**Office Action Summary**

09/558,694

GILBERT ET AL.

**FIGURE 1**

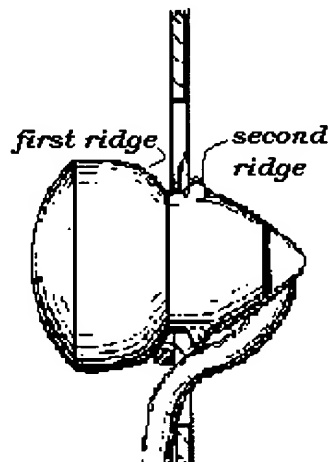
Blair discloses a charge holder (10) for accepting a case (12), the charge holder comprising a loading member including at least one hole disposed through a wall of the loading member (seen in figure 2), the hole having a circumference defining at least one tab (see detail below).

**Regarding claim 3**, Blair discloses a first and second ridge defining a groove between wherein the tab can be captured within the groove (see detail below).
